ADDENDUM NO. 2

CONTRACT NO. 19-514

Low Rise Building Renovations and HVAC Improvements
110 Dr. Martin Luther King Jr. Boulevard
White Plains, New York

PLUMBING PLAN - PUBLIC RESTROOMS AND UNISEX BATH

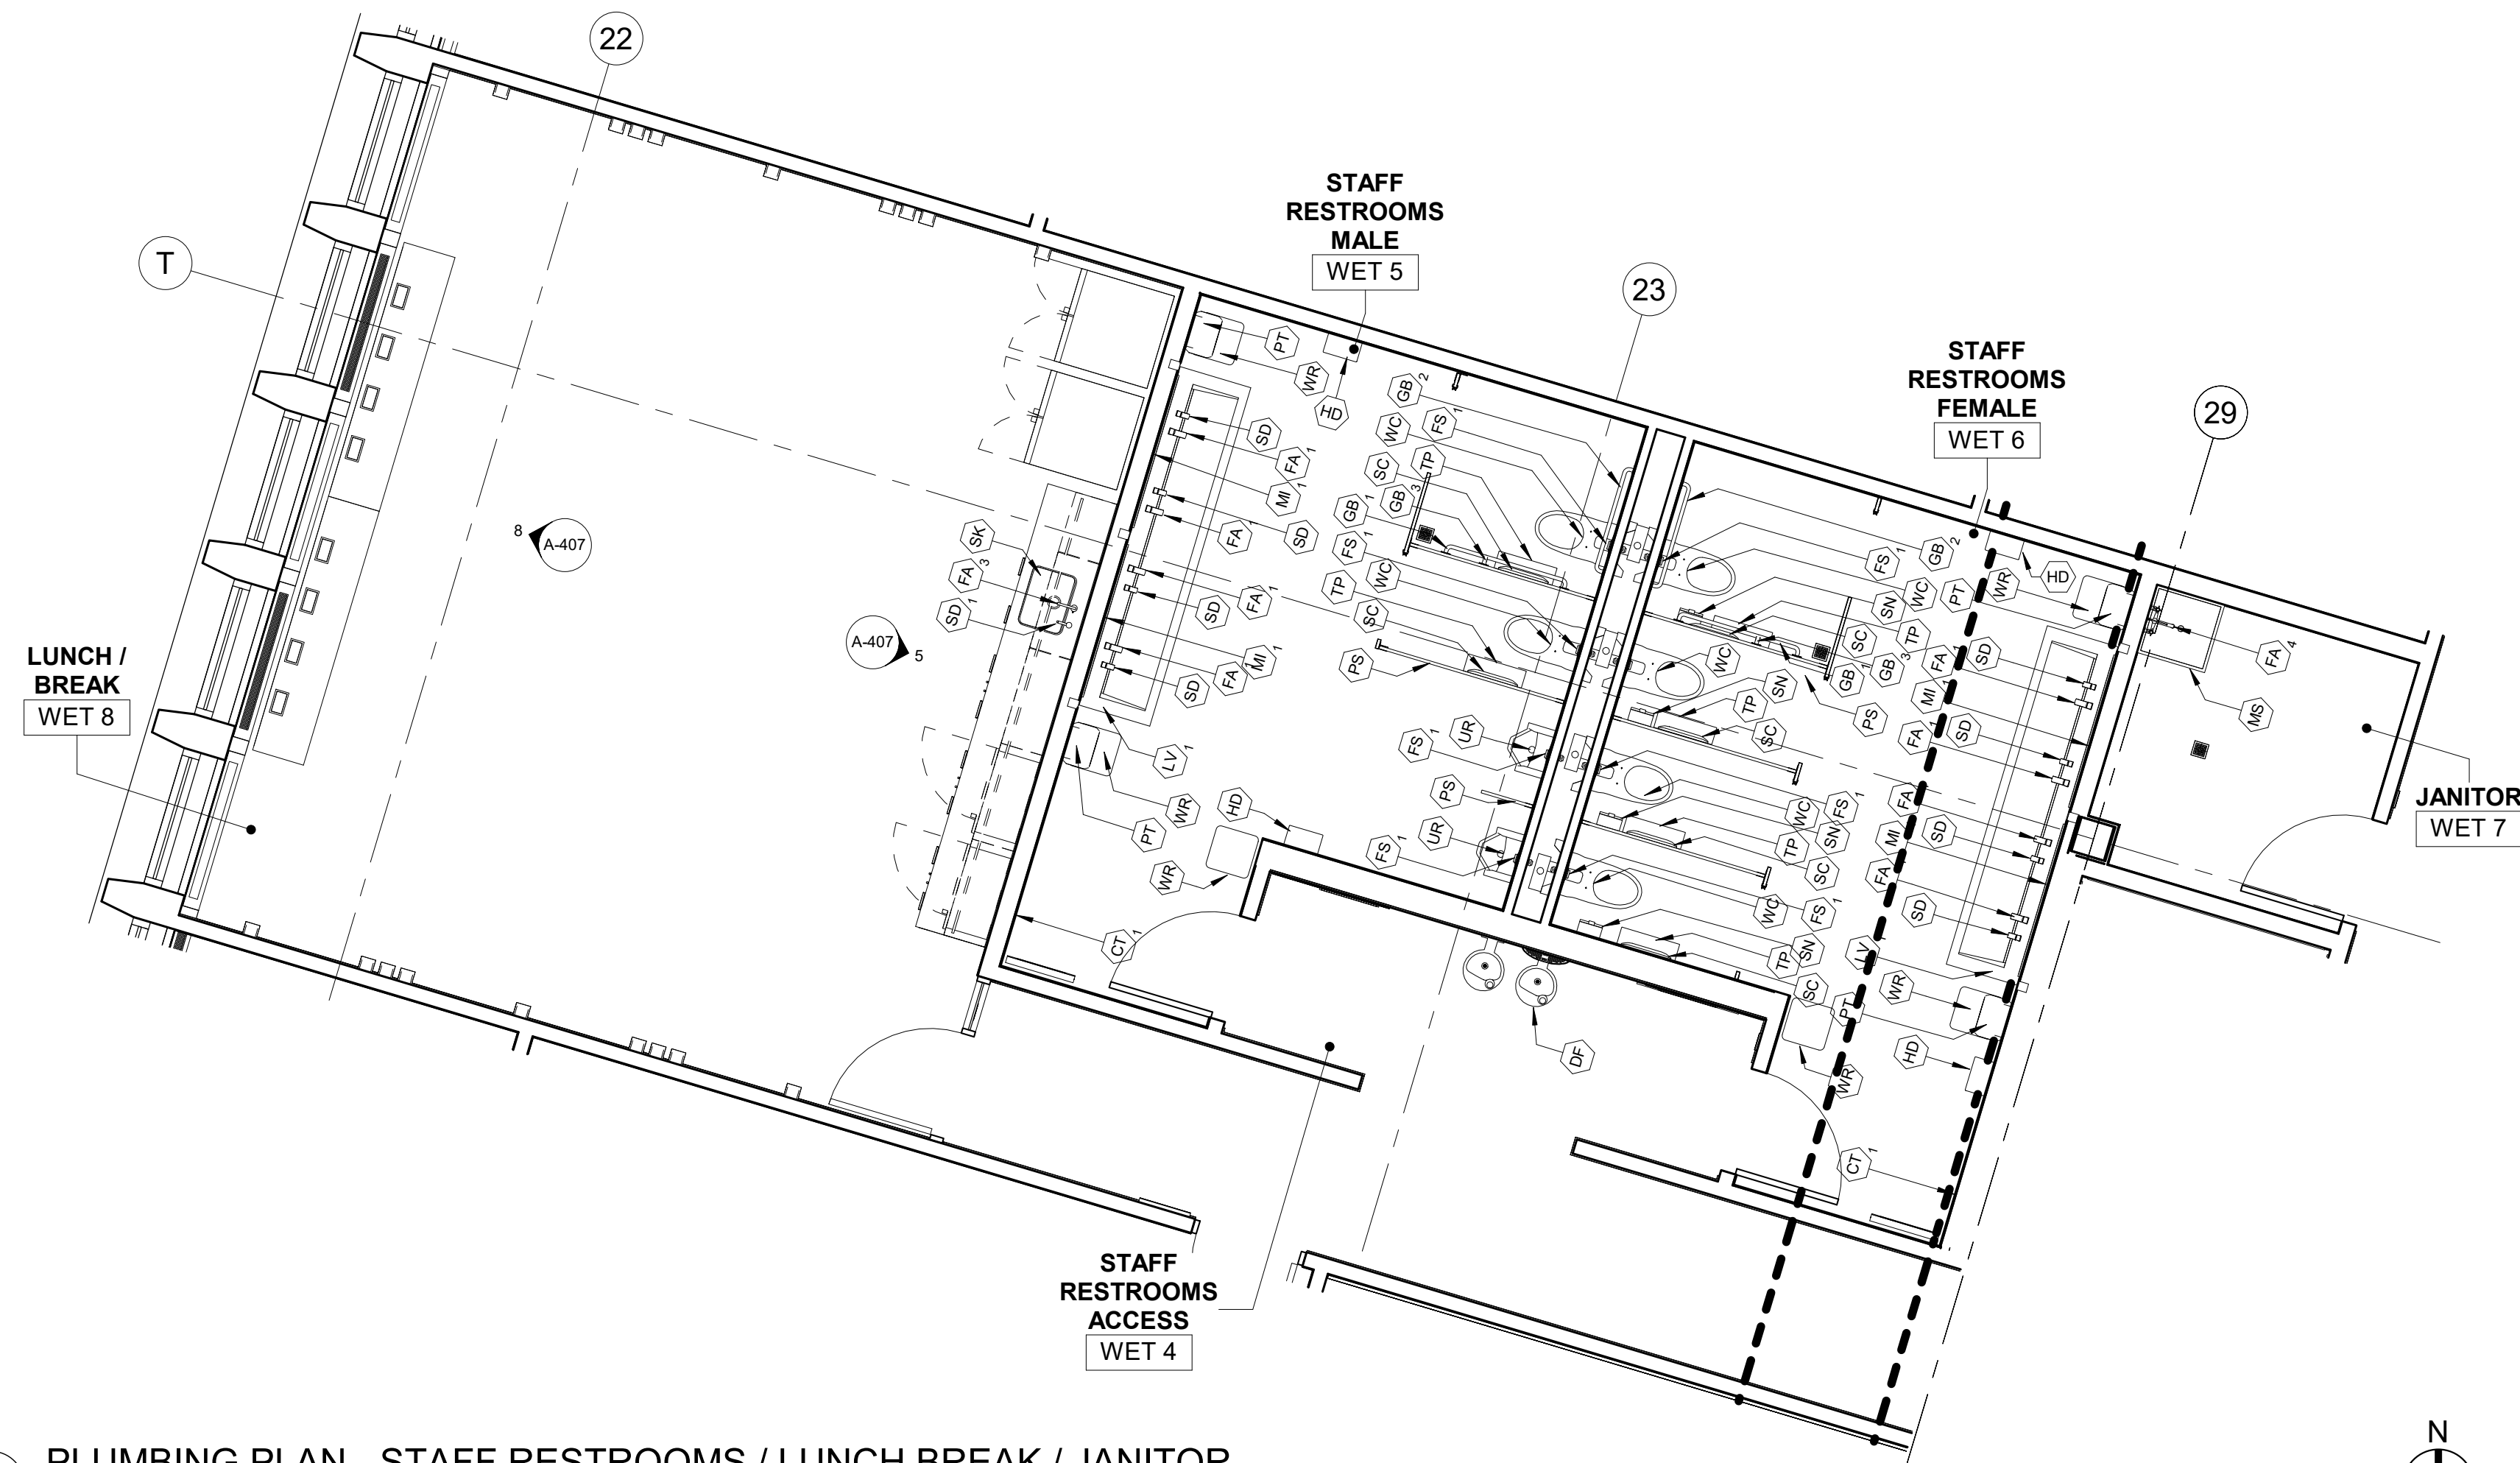
F. Plumbing Fixture Schedule Update: We have attached revised drawings A-141 and A-142. The Plumbing Fixture Schedule and Restroom Accessory Schedule on A-141 have been revised per the first Architectural question below. The Schedules have been removed from A-142 to avoid conflicts. No changes have been made to the plans, etc. on these drawings.
